TECHNICAL BULLETIN

[Issue No.] GOT-A-0098

[Title] Change of the Liquid Crystal Display for a GT27 Model

[Relevant Models] GOT2000 Series

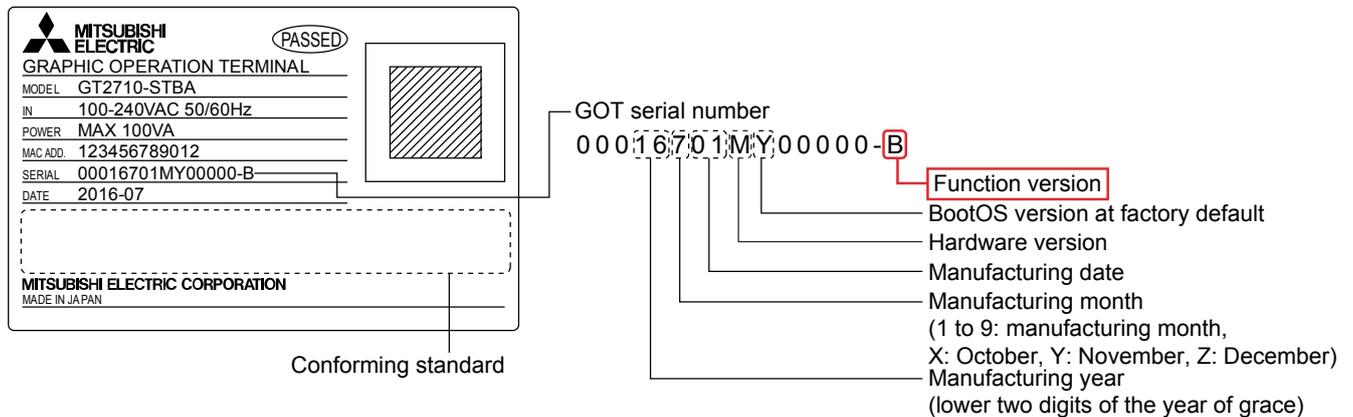
2. Details of change

The LCD of the target product is changed.
